Crescent Mark Up

client: ARROWSMITH BRUNSWICK SQUARE LTD. date: NOV 2024
project: BRUNSWICK MILL DEVELOPMENT PHASE 1 scale: 1:200 @A1 drawn by: TC
title: PROPOSED ROOF PLAN drawing number: L(20)207
status: STAGE 4 - FOR INFORMATION job number: 0586 revision: P5

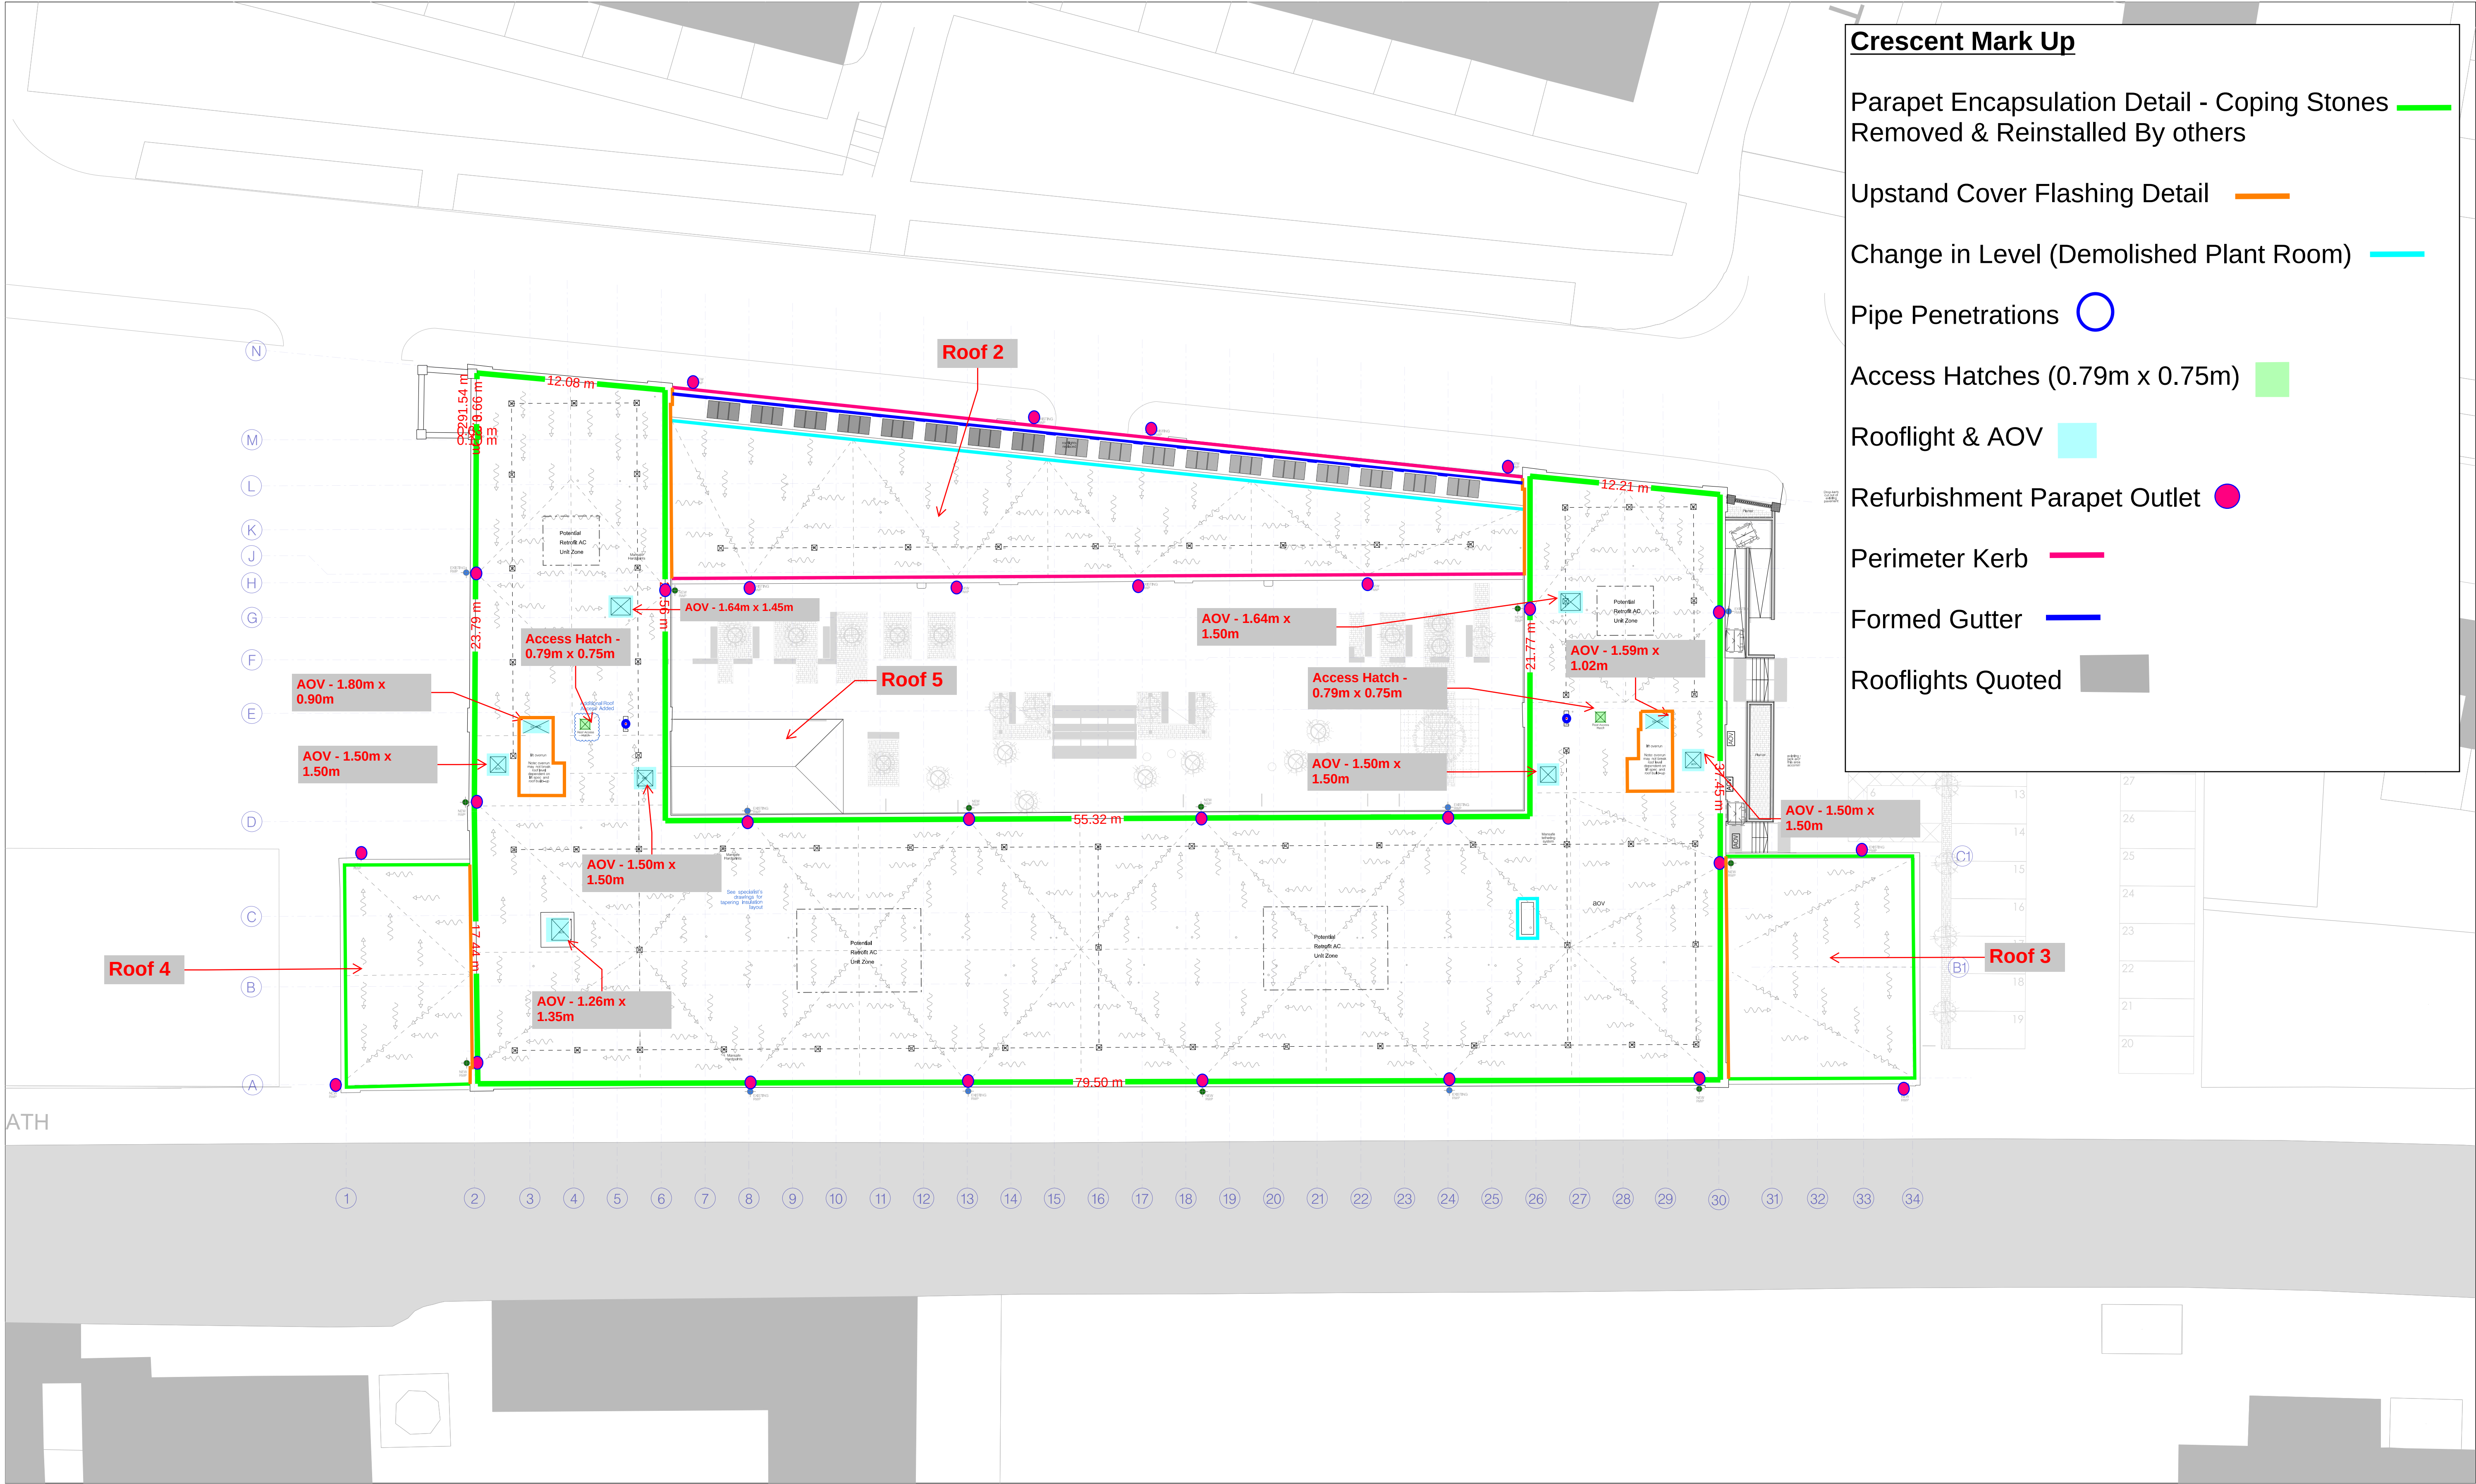
Parapet Encapsulation Detail - Coping Stones Removed & Reinstalled By others

Upstand Cover Flashing Detail

Change in Level (Demolished Plant Room)

Pipe Penetrations

Access Hatches (0.79m x 0.75m)

Rooflight & AOV

Refurbishment Parapet Outlet

Perimeter Kerb

Formed Gutter

Rooflights Quoted
